Subject: M1E1 CEU Potential Safety Hazard

Subject : Subcontract DEM 805001 (0178)
120mm Gun FSED
M1/IM1E1 CEU Interchangeability

Subject: Interchangeability of M1 and M1E1 CEUs.

FIG.1

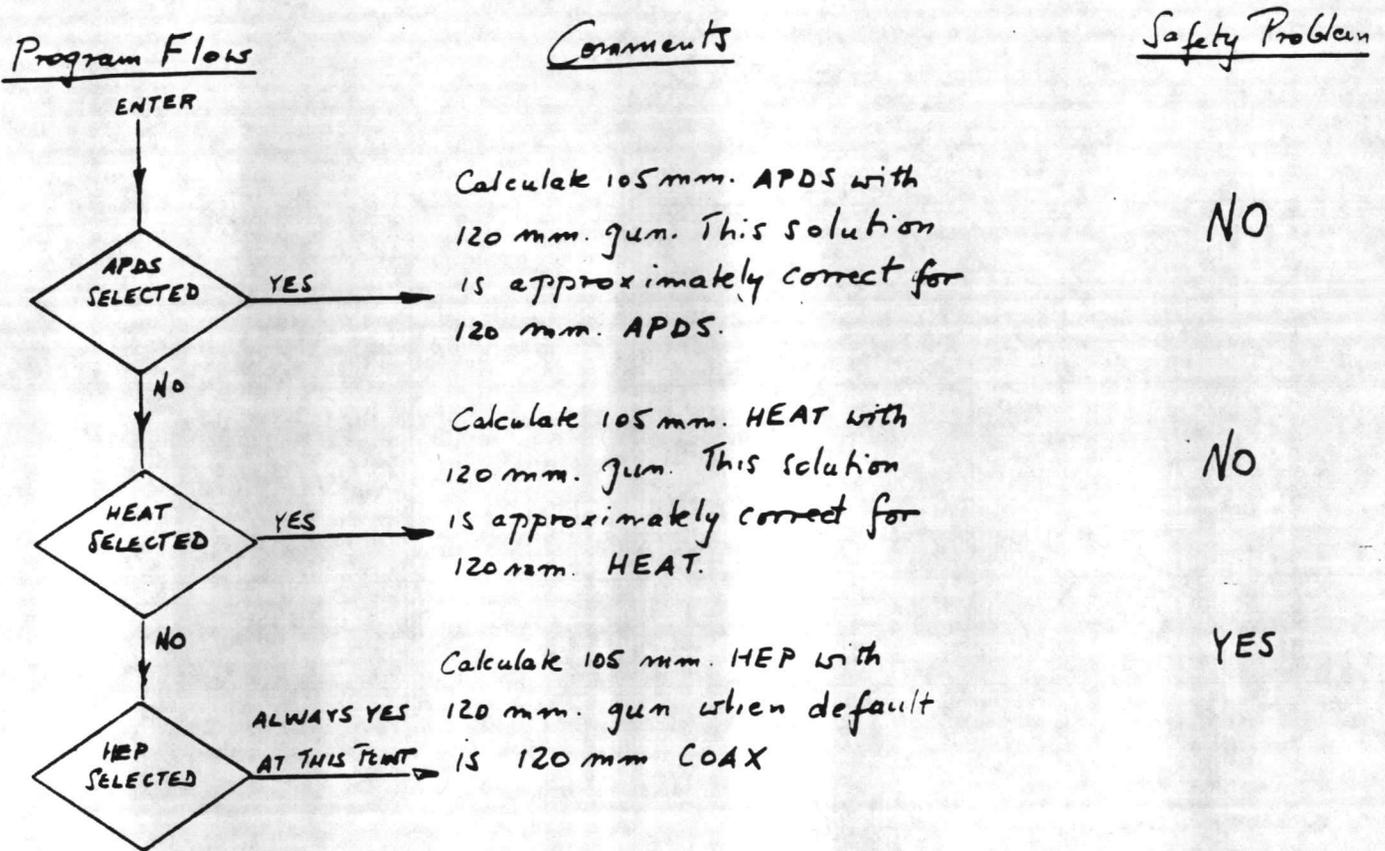
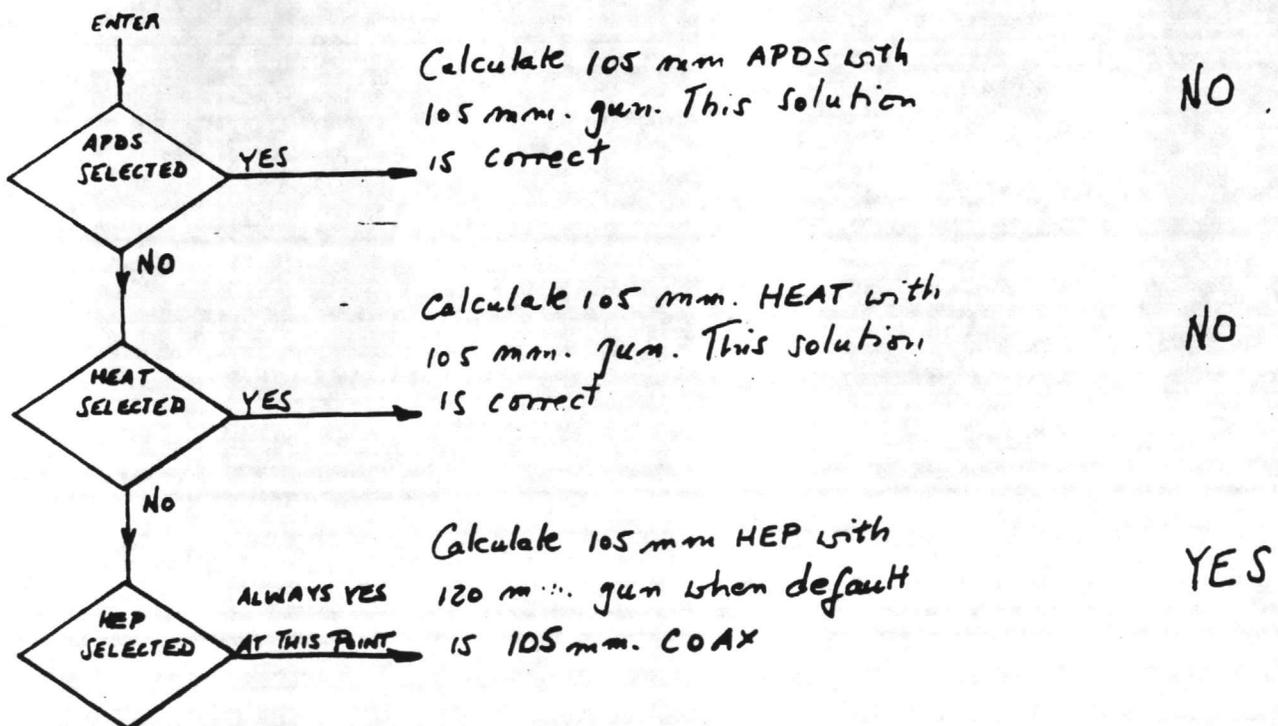
With an MI CEU installed in an IMIEI tank, no hardware safety problems would exist (by applying voltages to the outputs of IMIEI sensors), however software problems would as shown in Fig. 1. Please provide comments to the above suggestions.

IMIEI Tank with MI CEU Installed
